**Photo Report**

**Verdugo Park**

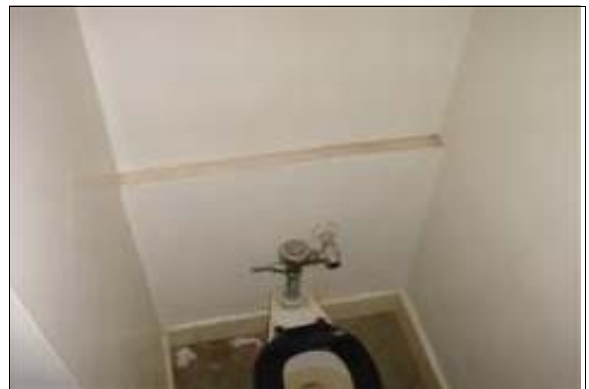
**Finding:** The urinal in the restroom is floor mounted and does not provide a tapered, elongated rim. The flush control valve on the urinal is greater than 44 inches above the finished floor.

**Full Rec:** Replace the urinal designated to be accessible in the restroom with a wall-mounted or stall-type tapered, elongated rim unit complying with ADAAG 4.18.2. The height of the rim surface of the urinal designated to be accessible shall not exceed 17 inches above the finished floor and the flush control valve shall not exceed a height of 44 inches above the finished floor.
